Access Compliance Report

Public Rights-of-Way

(Curb Ramps)

Intersection ID: 11231	Main Street: W_4TH_ST_EXT	Cross Street: WALNUT_AV	Location: SW
ADA ID: 53E7CC056F50	Ramp Type: Perp	Initial Pass/Fail: Fail	Overall Compliance: No
Severity Score: 1.25			
Codes/Mitigation Info/Possible Solution		Field Measurements/Component Compliance

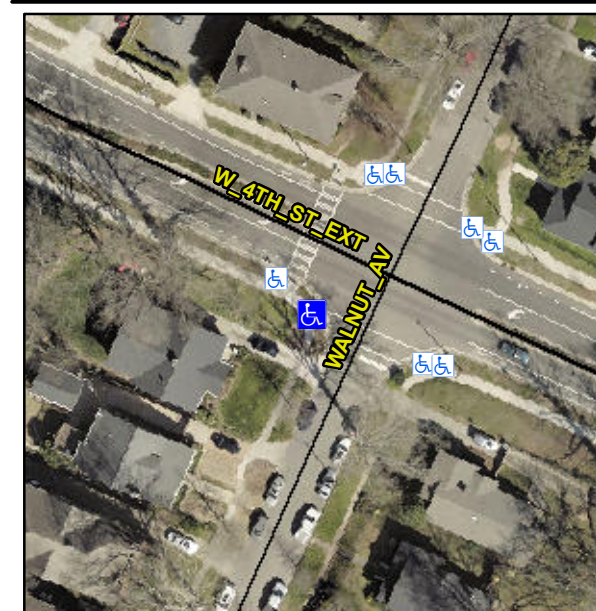
Not Found, R304.5.3

Compliance	Description	Data	Compliance	Description	Data
N/A	Ramp Length (in)	76.0	Yes	Ramp Slope (%)	7.0
Yes	Ramp Width (in)	69.0	No	Ramp XSlope (%)	2.6
N/A	Flare Type LT	N/A	N/A	Flare Type RT	N/A
N/A	Flare Slope LT (%)	N/A	N/A	Flare Slope RT (%)	N/A
N/A	Flare Traversable LT?	N/A	N/A	Flare Traversable RT?	N/A
N/A	Landing Length (in)	N/A	N/A	DWS Provided?	N/A
N/A	Landing Width (in)	N/A	N/A	DWS Contrast?	N/A
N/A	Landing Slope (%)	N/A	N/A	DWS Length (in)	N/A
N/A	Landing X Slope (%)	N/A	N/A	DWS Full Width?	N/A
N/A	Landing Curb? (Y/N)	N/A	N/A	DWS Offset (in)	N/A
N/A	Shared Landing?	N/A			
N/A	Gutter Ponding?	N/A	N/A	Gutter Slope (%)	N/A
N/A	Gutter Lip Ht (in)	N/A	N/A	Gutter X Slope (%)	N/A
N/A	Painted X Walk1?	No	N/A	Painted X Walk2?	N/A
	X Walk 1 Direction	To SE		X Walk 2 Direction	N/A
N/A	X Walk 1 Width (in)	N/A	N/A	X Walk 2 Width (in)	N/A
	X Walk 1 Slope (%)	2.1		X Walk 2 Slope (%)	N/A
	X Walk 1 X Slope (%)	2.6		X Walk 2 X Slope (%)	N/A

Remove & Replace Entire Ramp.
